OPERABLE UNIT 1 REVISED SITE PREPARATION DRAWINGS

OPERABLE UNIT 1 REVISED SITE PREPARATION DRAWINGS

SUBMITTAL OF REVISION 1 OF THE OPERABLE UNIT 1 SITE PREPARATION PACKAGE

OU1 REMEDIATION SYSTEM DESIGN
SITE IMPROVEMENT
PROJECT ORDER 145

DRAWING TITLE
CIVIL
SITE PLAN/DEMOLITION PLAN

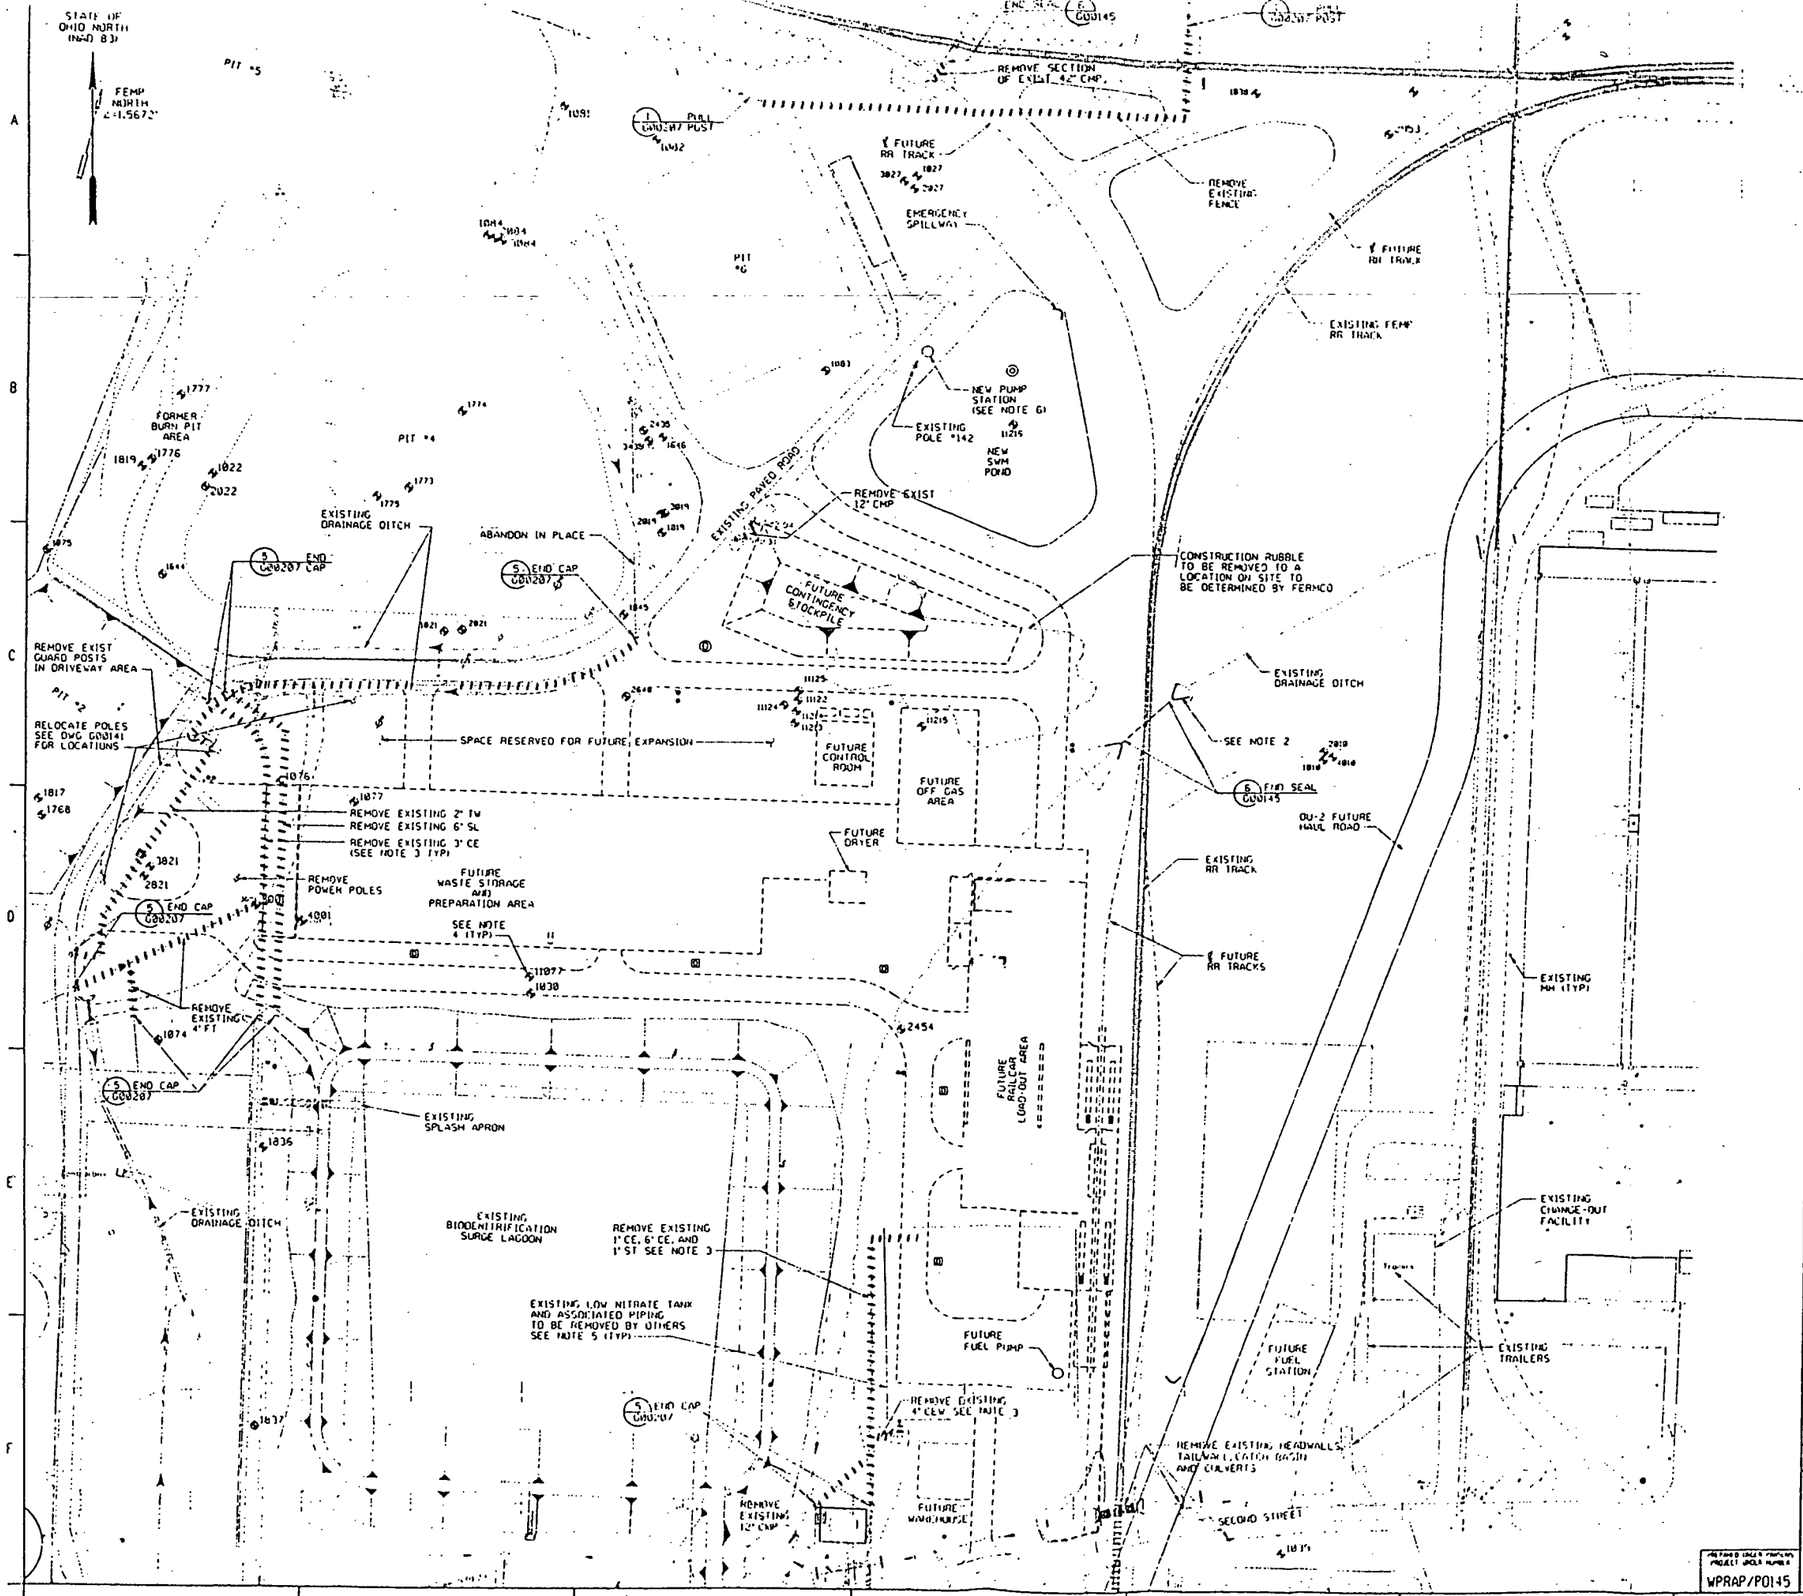
8) The underground piping at the low nitrate tank was called out for removal on the site demolition plan.

DRAWING TITLE
CIVIL
GRADING PLAN
SHEET 1 OF 2

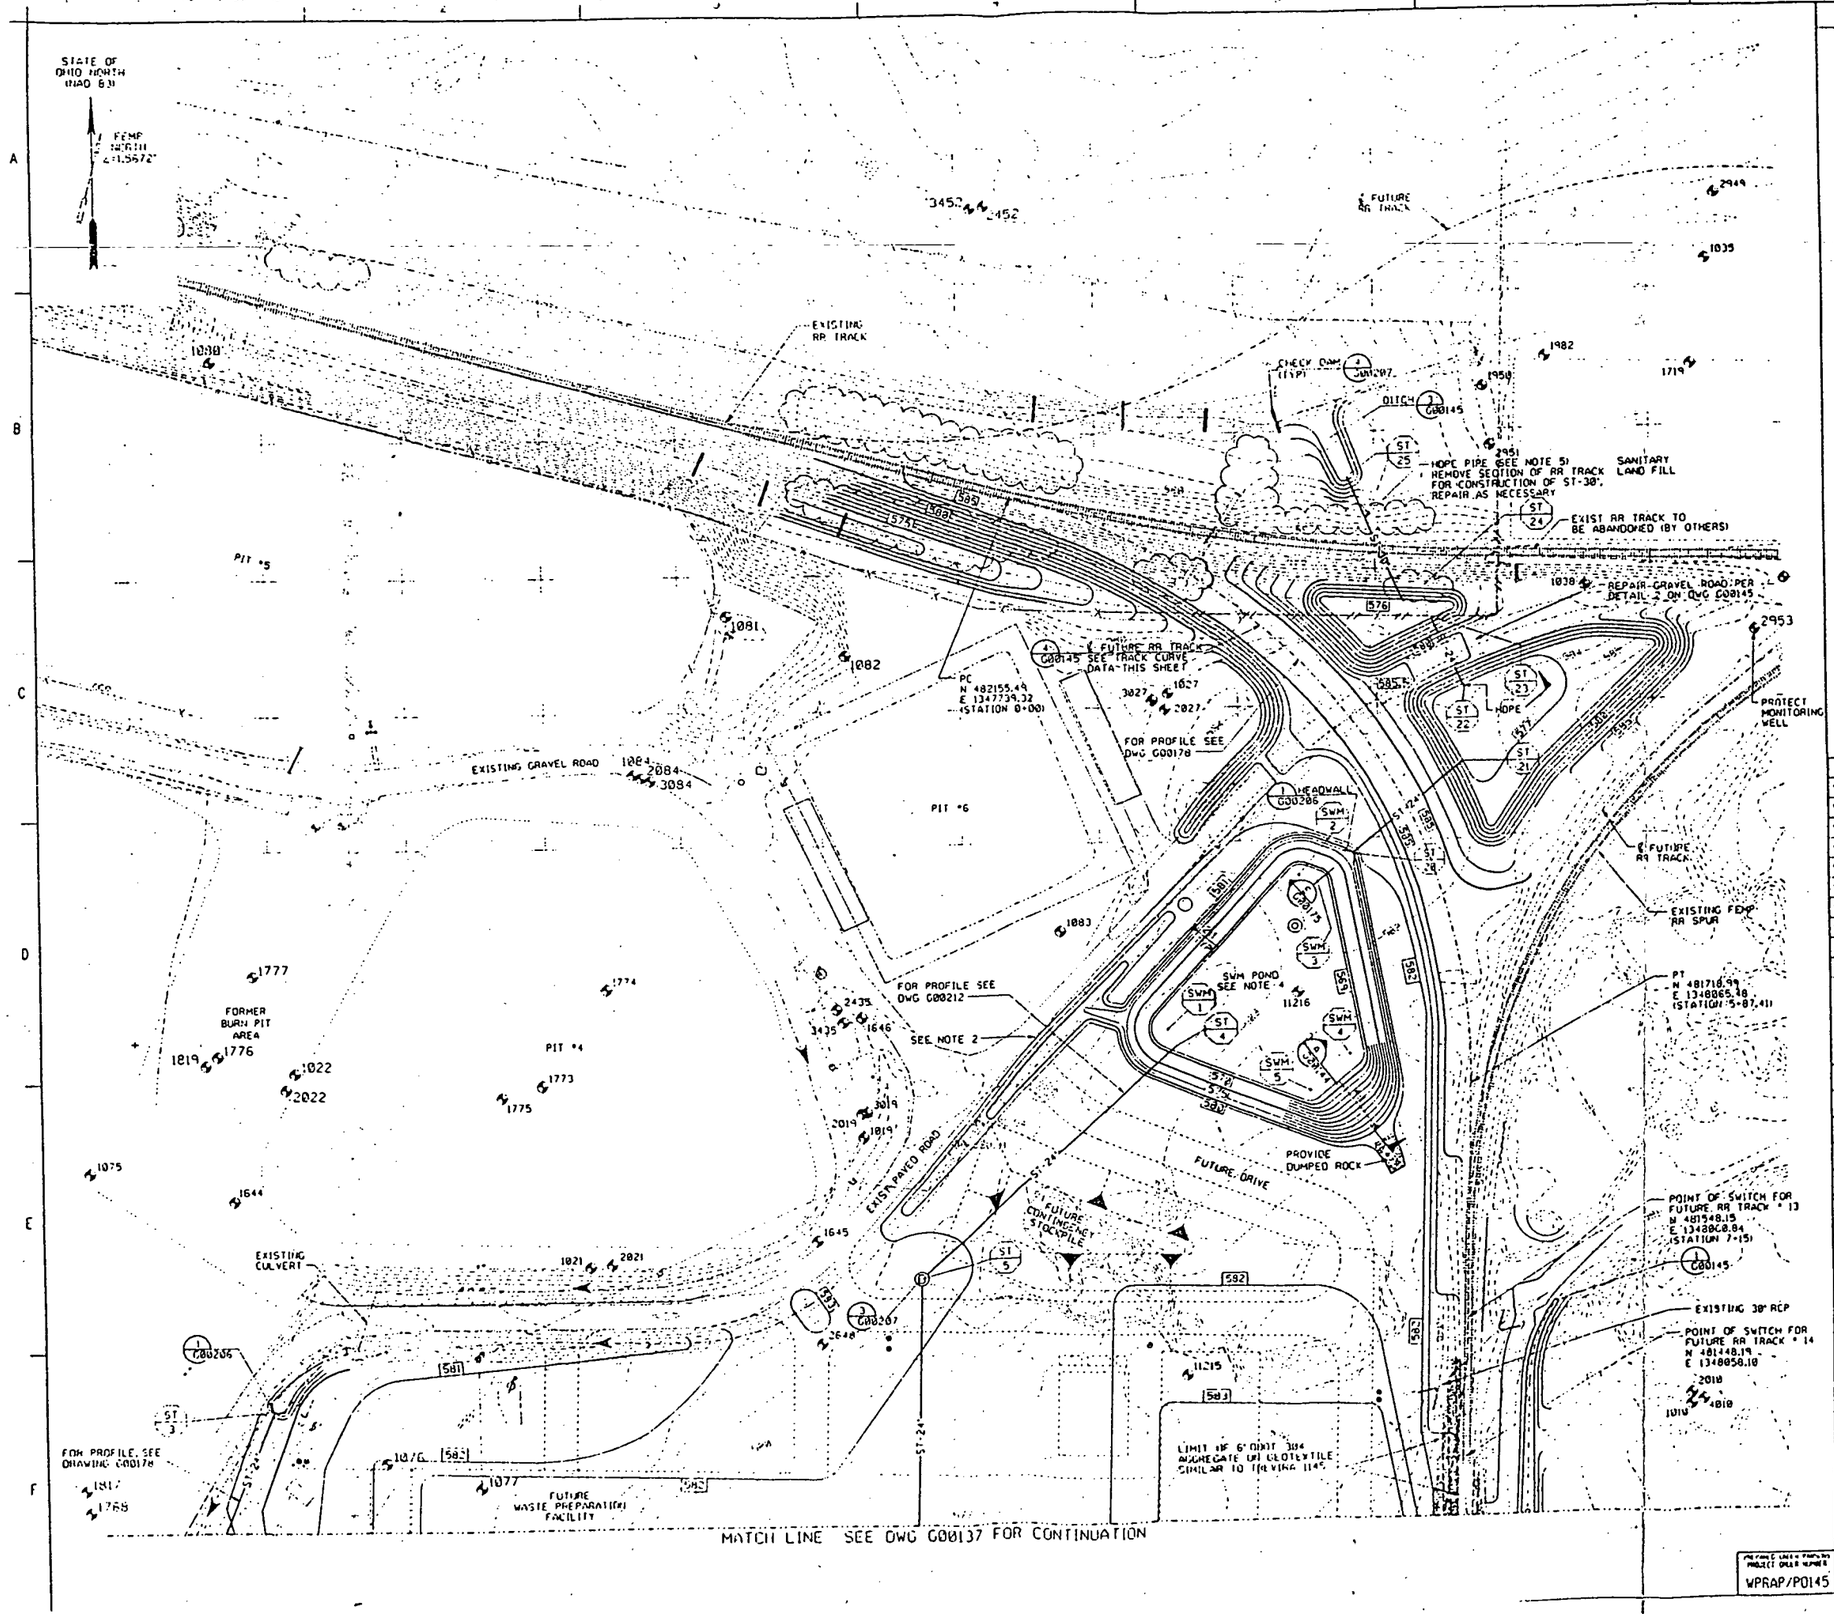
6) The depth of the storm water management (SWM) basin was reduced. Also, the piping for discharge of the greater than 25 year storm flow was rerouted through both retention areas to the north of the SWM.

RAILROAD SUBGRADE PROFILE (5 / G00178) REF G00136
SCALE: HOR 1"=40' VER 1"=5'

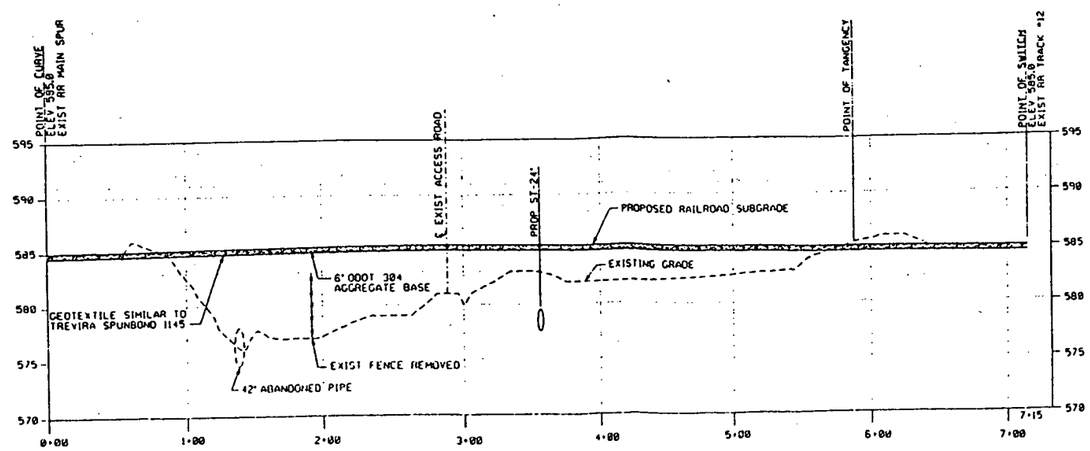
7) A top/subgrade centerline profile was included for the railroad embankment for the west leg of the "wye".
